INTERNAL MEMORANDUM

SUBJECT: P/23/0065 | Outline application for erection of a mixed leisure development comprising Indoor Snow Centre (up to 39,200 sq m), Water park (up to 7,500 sq m), Indoor Activity Centre (up to 9,000 sq m), Outdoor Activity Centre, Hotel Accommodation (up to 418 bedrooms), Woodland Lodge accommodation (up to 30 units), car parking (up to 830 spaces) and associated earthworks, access, drainage, servicing and utilities connections/infrastructure | Land To The South West Of The A470/A4102 Roundabout At Rhydycar West Merthyr Tydfil

1. Rhydyar West. Environmental Statement. Volume 1: Main Text. March 2023.
 - a) Chapter 8: Ecology (plus Appendices 8.1 – 8.14)
 - b) Chapter 16: Lighting (plus Appendix 16.1)

See below for an overlay of Figures 4.3 (Modelled Ecological Receptors) and 5.1 (Indicative External Lighting Layout)

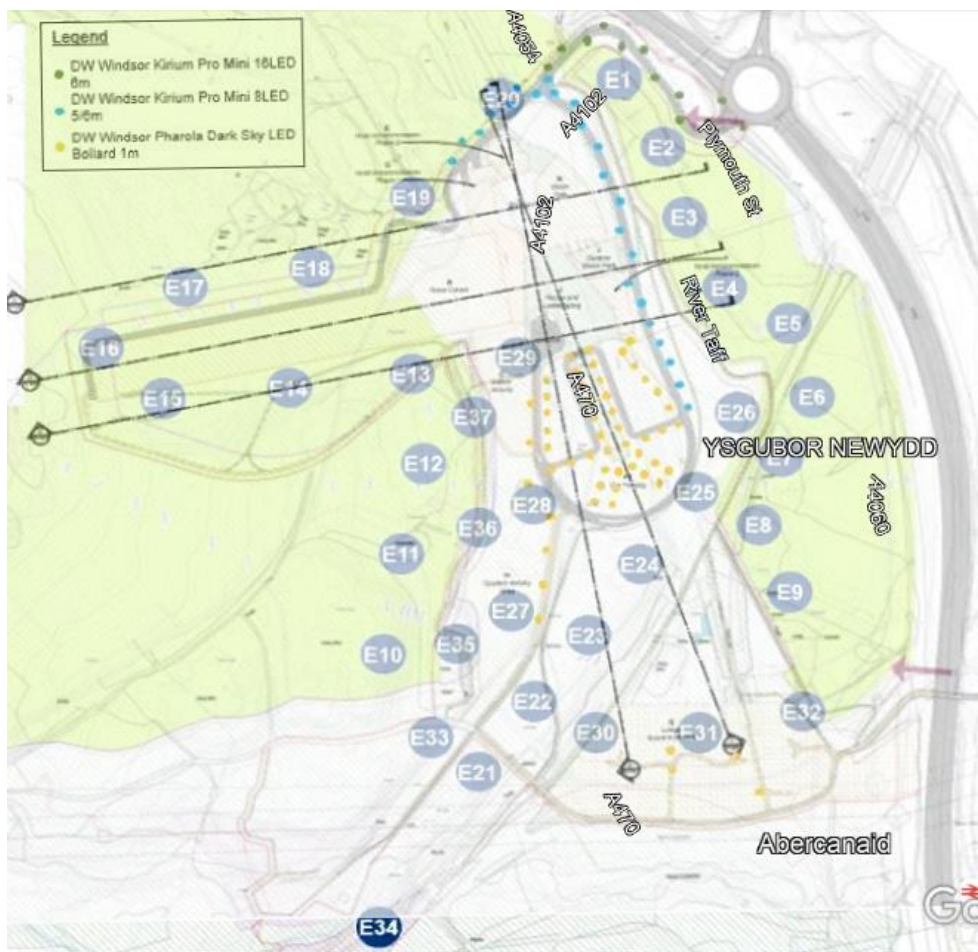
Table 5.2, pages 25-26 shows the Ecological Receptor Assessment Results. NB there is no unit specified within this table – I assume the unit is lux? This needs to be explicit.

The highest predicted model illuminance of the chosen Ecological Receptors is shown at E3 (0.05lux), but for example, the predicted model illuminance at E20 and E28 is lower at 0.01lux and 0.02lux respectively. This seems counterintuitive, as E20 and E28 are closer to proposed luminaires than E3? To further illustrate this point, the two Ecological Receptors either side of E3 (E2 and E4) are in similar positions, but both have lower predicted model illuminance (0.01lux and 0.02 lux respectively).

Also, E20 seems to be very close to a line of lighting columns, yet the illuminance level is very low (0.01lux). Is this correct?

In addition, Table 4.2 shows the baseline lux levels and, for example, location 1 (L1) has an illuminance level of 0.05lux (facing east). L1 is in the same position as E20, but the 'baseline' illuminance level (pre-lighting) is higher than the predicted model illuminance (post-lighting)?

Can this be explained please?
